Access Audit Site Report

Mother Neff State Park
1921 Park Road 14
Moody, TX 76557
Accessibility Evaluation
Inspection Date: 09/29/2022
Inspectors: Tanya Scheibe

Prepared By
WT Group

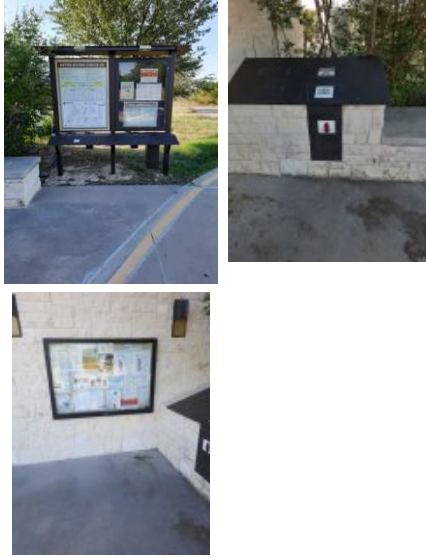
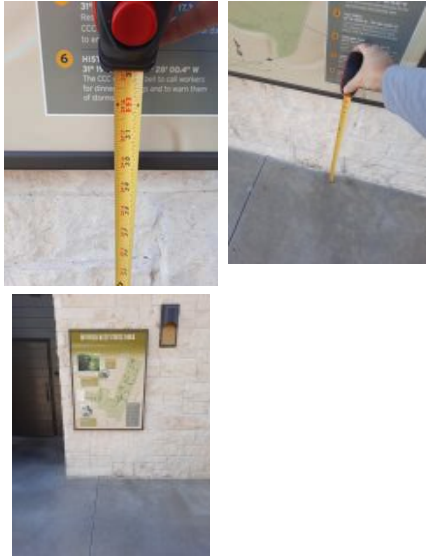
Finding Number	Area Description	Lat/Long	Finding	As Built	Recommendation	Citation	Photos	Figure
5	Headquarters Area: HQ - Parking	[31.3339601 , -97.467958 3]	The parking stall contains abrupt edges and surface irregularities over a 1/4 inch vertical. Parking spaces and access aisles serving them shall be stable, firm, and slip resistant. Access aisles shall be at the same level as the parking spaces they serve. Changes in level are not permitted and shall not be sloped steeper than 2% in any direction.	HQ main parking - .5" change in elevation (CIL) and gap of 1" at head of access aisle (AA)	Repair, bevel and ramp CIL in stalls and access aisles. Correct or fill gaps in parking surfaces.	2015 ABAAS Section: 502.4 2012 TAS Section: 502.4 2010 ADAS Section: 502.4

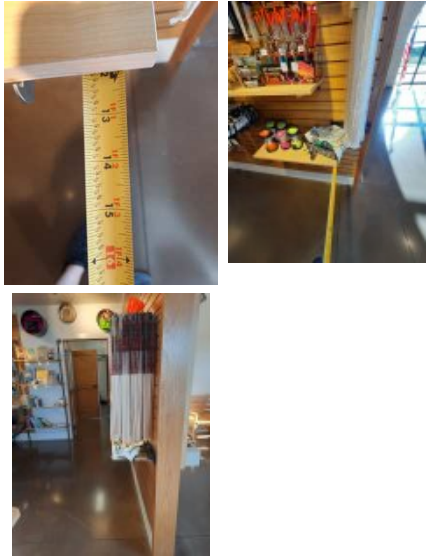
8	Headquarters Area: HQ - Exterior Accessible Route	[31.334, -97.46782]	There is a gap spaced greater than a 1/2 inch. Openings in floor or ground surfaces shall not allow passage of a sphere more than 1/2 inch diameter. Elongated openings shall be placed so that the long dimension is perpendicular to the dominant direction of travel.	1" gap on walkway from main parking towards HQ building	Correct or fill gaps to be max .5".	2015 ABAAS Section: 302.3 2012 TAS Section: 302.3 2010 ADAS Section: 302.3

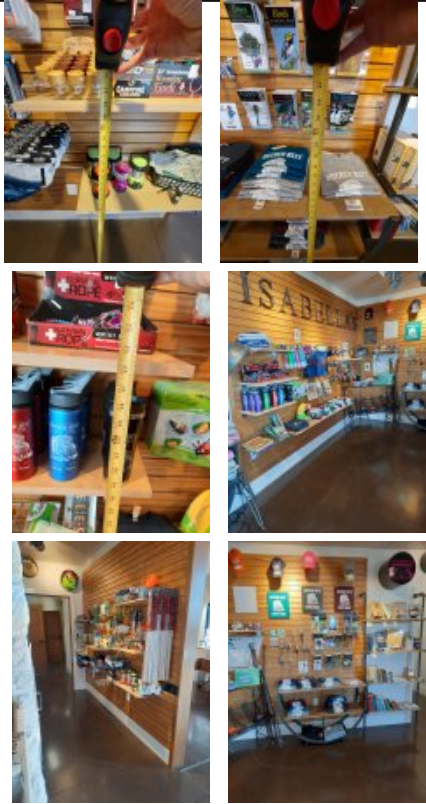
Finding Number	Area Description	Lat/Long	Finding	As Built	Recommendation	Citation	Photos	Figure
9	Headquarters Area: HQ - Exterior Accessible Route	[31.334089, -97.467477 6]	There is a gap spaced greater than a 1/2 inch. Openings in floor or ground surfaces shall not allow passage of a sphere more than 1/2 inch diameter. Elongated openings shall be placed so that the long dimension is perpendicular to the dominant direction of travel.	.75" gap towards overflow parking, 1" gap, 1.25" gap, 6 more similar gaps at expansion joints	Correct or fill gaps to be max .5".	2015 ABAAS Section: 302.3 2012 TAS Section: 302.3 2010 ADAS Section: 302.3		
10	Headquarters Area: HQ - Exterior Accessible Route	[31.3339906, -97.46794 61], [31.3340044, -97.467349 3]	The accessible route of travel that crosses or adjoins the vehicular way and the walking surface is not separated by curbs, railings, or other elements between the pedestrian areas and vehicular areas. If a walk crosses or adjoins a vehicular way, and the walking surfaces are not separated by curbs, railings or other elements between the pedestrian areas and vehicular areas, the boundary between the areas shall be defined by a continuous detectable warning which is 36 inches wide.	Lacks detectable warning at both access aisles at both parking lots	Install detectable warning where accessible route crosses the vehicular way as a smart practice.	2012 TAS Section: 705.1 2010 ADAS Section: 705

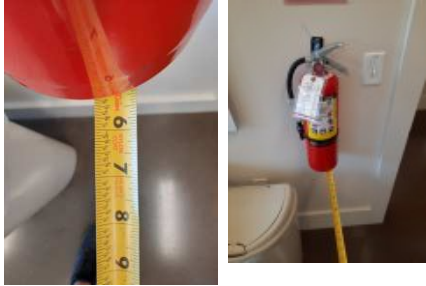
Finding Number	Area Description	Lat/Long	Finding	As Built	Recommendation	Citation	Photos	Figure
23	Headquarters Area: HQ - Public Spaces	[31.3342419 , -97.467872 4]	The operable part is positioned too high for either a side or front approach. Where a clear floor or ground space allows a parallel approach to an element and the side reach is unobstructed, the high side reach shall be 48 inches maximum and the low side reach shall be 15 inches minimum above the finish floor or ground. Where a forward reach is unobstructed, the high forward reach shall be 48 inches maximum and the low forward reach shall be 15 inches minimum above the finish floor or ground.	HQ Main Public Room: Fire alarm pull - 49.25" above the finished floor (AFF), donation box slot - 48.5" AFF, top 3 shelves of brochure rack are 53.5" AFF or higher, many merchandise items and shelves over 48" AFF	Remount operable parts to be in reach range of 15" min to 48" max.	2015 ABAAS Section: 308.1 2012 TAS Section: 308.1 2010 ADAS Section: 308.1

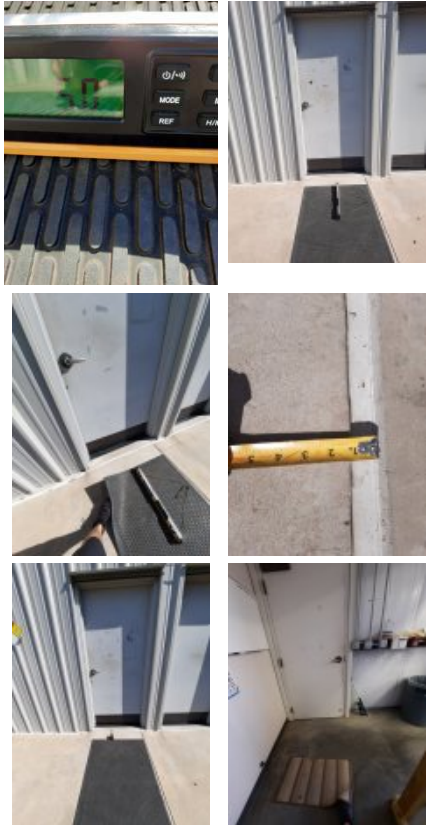
52	Headquarters Area: HQ - Women's Restrom	[31.3341279 , -97.467872]	Minimum maneuvering clearances at doors and gates shall comply with 404.2.4. Maneuvering clearances shall extend the full width of the doorway and the required latch side or hinge side clearance. Exterior doors are recommended to be maintained at 8.5 lbf as a smart practice. Force is to be measured at the operating hardware or 30 inches from the hinges, whichever is greater.	HQ women's restroom door - loose floor mat on push side, 13# push	For all doors along the public circulation route, provide required maneuvering clearance on push and pull side of doors. For all doors along the public circulation route, secure rug in door clearance to prevent trip hazard. For all doors along the public circulation route, inspect, adjust, and maintain 8.5 lbf to open exterior doors as a smart practice.	2010 ADAS Section: 404.2.3, 404.2.7, 404.2.4, 404.2.11, 404.2.11 Exception

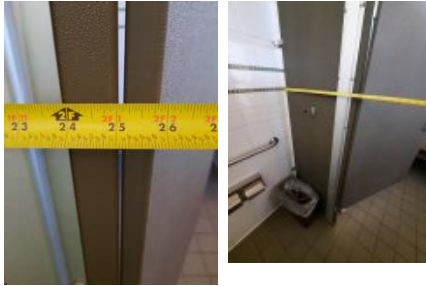
134	Full Hook-Up Campsites: Full Hook-Up - Men's Restroom	[31.3268565 , -97.4686367]	The compartment door is located too far from the partition or wall. The door shall be located in front of the clear space and diagonal to the water closet. Where located in the front partition, the door opening shall be 4 inches maximum from the side wall or partition farthest from the water closet. Where located in the side wall or partition, the door opening shall be 4 inches maximum from the front partition. Toilet compartment doors shall not swing into the minimum required compartment area.	23.5" from wall	Rehang stall door to be max 4" from adjacent stall partition and on the stall wall farthest from the toilet.	2015 ABAAS Section: 604.8.1.2 2012 TAS Section: 604.8.1.2 2010 ADAS Section: 604.8.1.2		
135	Full Hook-Up Campsites: Full Hook-Up - Men's Restroom	[31.3268558 , -97.4686362]	Exterior doors exceed 8.5 lbs of force to open; fire doors shall have a minimum opening force allowable by the appropriate administrative authority	Men's restroom door at Full-hookup campground - 15# push	Inspect, adjust, and maintain 8.5 lbf to open exterior doors as a smart practice.	2010 ADAS Section: 404.2.9

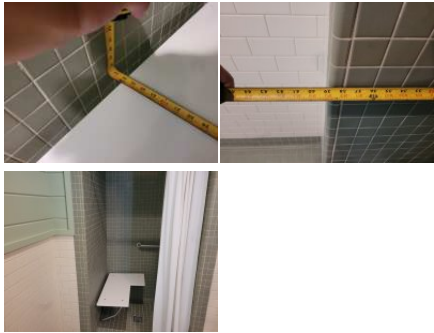
Finding Number	Area Description	Lat/Long	Finding	As Built	Recommendation	Citation	Photos	Figure
160	Full Hook-Up Campsites: Full Hook-Up - Elements	[31.3268217 , -97.468704 4]	The operable part is not accessible because it requires tight grasping, pinching or twisting of the wrist.	Bolt lock on little Free Library at restrooms in Full Hook-Up Campground requires tight pinch and sticks when opening	Replace operable part with one usable without a tight pinch or grasp.	2015 ABAAS Section: 309.4 2012 TAS Section: 309.4 2010 ADAS Section: 309.4

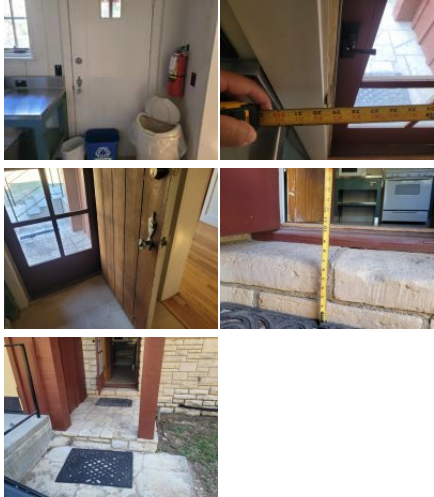
167	CCC Cabin: CCC Cabin - Cabin	[31.32133, -97.46915]	The top of the work surface is not within a compliant height range. The tops of tables and counters shall be 28 inches to 34 inches from the floor or ground.	Desk lacks knee clearance	Provide tables and work surfaces at 28" to 34" AFF with required knee and toe clearances.	2015 ABAAS Section: 902.3 2012 TAS Section: 902.3 2010 ADAS Section: 902.3	  	
168	CCC Cabin: CCC Cabin - Cabin	[31.3212401 , -97.469171 7]	Element meets all standards and requirements	Bed has CFS both sides in bedroom by accessible entry	None	2010 ADAS Section: N/A		
169	CCC Cabin: CCC Cabin - Cabin	[31.3212535 , -97.469187 2]	Element meets all standards and requirements	compliant doors-bedroom by accessible entry, bathroom by accessible entry	None	2010 ADAS Section: N/A

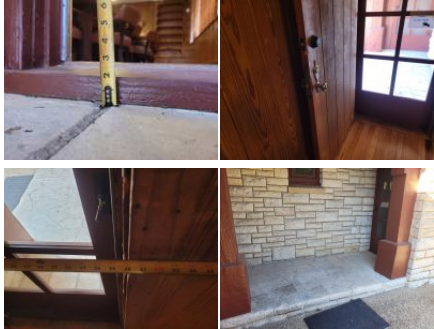
174	CCC Cabin: CCC Cabin - Cabin	[31.3213116 , -97.469172 2]	Transfer type shower compartments shall be 36 inches (915 mm) by 36 inches (915 mm) clear inside dimensions measured at the center points of opposing sides and shall have a 36 inch (915 mm) wide minimum entry on the face of the shower compartment. Clearance of 36 inches (915 mm) wide minimum by 48 inches (1220 mm) long minimum measured from the control wall shall be provided.	Restroom - Shower dimensions not compliant - 37.5" x 39"	Renovate transfer shower to compliant 36" by 36" clear inside dimension.	2015 ABAAS Section: 608.2.1 2012 TAS Section: 608.2.1 2010 ADAS Section: 608.2.1		
175	CCC Cabin: CCC Cabin - Cabin	[31.3213162 , -97.469157 4]	The shower seat is located too far from the opening to the shower. A seat in a standard roll-in shower compartment shall be a folding type, shall be installed on the side wall adjacent to the controls, and shall extend from the back wall to a point within 3 inches of the compartment entry.	Restroom - Seat 5" from shower entry	Remount shower seat so that the front edge is within 3" of the opening.	2015 ABAAS Section: 610.3 2012 TAS Section: 610.3 2010 ADAS Section: 610.3

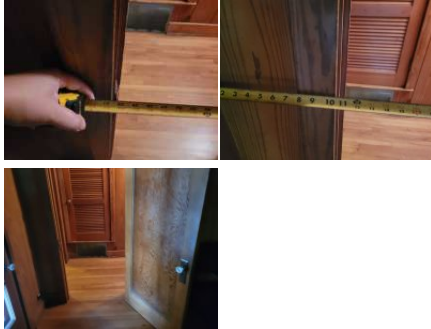
Finding Number	Area Description	Lat/Long	Finding	As Built	Recommendation	Citation	Photos	Figure
178	CCC Cabin: CCC Cabin - Cabin	[31.321206, -97.4691608]	<p>Door openings shall provide a clear width of 32 inches (815 mm) minimum. Clear openings of doorways with swinging doors shall be measured between the face of the door and the stop, with the door open 90 degrees. Openings more than 24 inches (610 mm) deep shall provide a clear opening of 36 inches (915 mm) minimum. There shall be no projections into the required clear opening width lower than 34 inches (865 mm) above the finish floor or ground. Projections into the clear opening width between 34 inches (865 mm) and 80 inches (2030 mm) above the finish floor or ground shall not exceed 4 inches (100 mm). The threshold has a vertical change greater than 1/4 inch high. The threshold at a doorway shall be no higher than 1/2 inch. Changes in level between 1/4 inch and 1/2 inch must be beveled at 1:2 or less. 1/4 inch is the maximum vertical rise. Hand-activated door opening hardware, handles, pulls, latches, locks, and other operating devices on accessible doors shall have a shape that is easy to grasp with one hand and does not require tight grasping, tight pinching or twisting of the wrist to operate. Hardware shall be 34 inches minimum and 48 inches maximum above the finish floor or ground.</p>	Doors to patio (4) - steps to access, 29" wide, knobs, threshold 2.5"	For all doors along the public circulation route, replace one door with door having 80" overhead clearance and 32" clear width. For one door along the public circulation route, ramp steps at entry. For one door along the public circulation route, provide beveled threshold. For one door along the public circulation route, replace hardware with lever hardware or hardware operable without a tight pinch or grasp.	2010 ADAS Section: 404.2.3, 404.2.7, 404.2.4, 404.2.11, 404.2.11 Exception

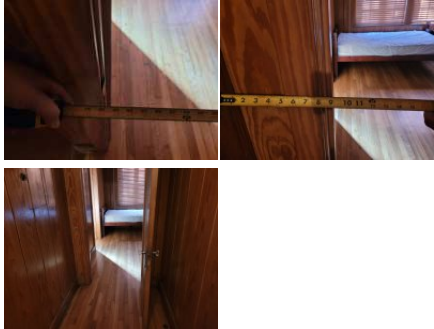
Finding Number	Area Description	Lat/Long	Finding	As Built	Recommendation	Citation	Photos	Figure
179	CCC Cabin: CCC Cabin - Cabin	[31.3212303 , -97.469155 8]	Door openings shall provide a clear width of 32 inches (815 mm) minimum. Clear openings of doorways with swinging doors shall be measured between the face of the door and the stop, with the door open 90 degrees. Openings more than 24 inches (610 mm) deep shall provide a clear opening of 36 inches (915 mm) minimum. There shall be no projections into the required clear opening width lower than 34 inches (865 mm) above the finish floor or ground. Projections into the clear opening width between 34 inches (865 mm) and 80 inches (2030 mm) above the finish floor or ground shall not exceed 4 inches (100 mm). The threshold has a vertical change greater than 1/4 inch high. Hand-activated door opening hardware, handles, pulls, latches, locks, and other operating devices on accessible doors shall have a shape that is easy to grasp with one hand and does not require tight grasping, tight pinching or twisting of the wrist to operate. Hardware shall be 34 inches minimum and 48 inches maximum above the finish floor or ground.	Kitchen door - steps pull side, 29" wide, knob	For all doors along the public circulation route, replace doors with doors having 80" overhead clearance and 32" clear width. For all doors along the public circulation ramp steps at entry. For all doors along the public circulation route, replace hardware with lever hardware or hardware operable without a tight pinch or grasp.	2010 ADAS Section: 404.2.3, 404.2.7, 404.2.4, 404.2.11, 404.2.11 Exception

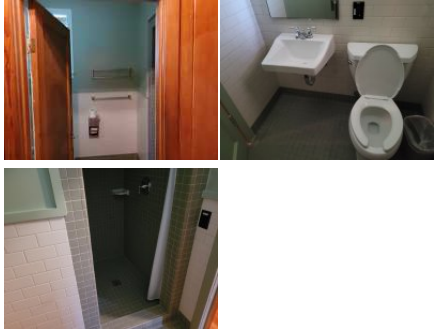
Finding Number	Area Description	Lat/Long	Finding	As Built	Recommendation	Citation	Photos	Figure
185	CCC Cabin: CCC Cabin - Cabin	[31.32123, -97.46915]	<p>Door openings shall provide a clear width of 32 inches (815 mm) minimum. Clear openings of doorways with swinging doors shall be measured between the face of the door and the stop, with the door open 90 degrees. Openings more than 24 inches (610 mm) deep shall provide a clear opening of 36 inches (915 mm) minimum. There shall be no projections into the required clear opening width lower than 34 inches (865 mm) above the finish floor or ground. Projections into the clear opening width between 34 inches (865 mm) and 80 inches (2030 mm) above the finish floor or ground shall not exceed 4 inches (100 mm). Hand-activated door opening hardware, handles, pulls, latches, locks, and other operating devices on accessible doors shall have a shape that is easy to grasp with one hand and does not require tight grasping, tight pinching or twisting of the wrist to operate. Hardware shall be 34 inches minimum and 48 inches maximum above the finish floor or ground.</p>	Door from hall to older bedrooms - 29" wide, knob	For all doors along the public circulation route, replace doors with doors having 80" overhead clearance and 32" clear width. For all doors along the public circulation route, replace hardware with lever hardware or hardware operable without a tight pinch or grasp.	2010 ADAS Section: 404.2.3, 404.2.7, 404.2.4, 404.2.11, 404.2.11 Exception
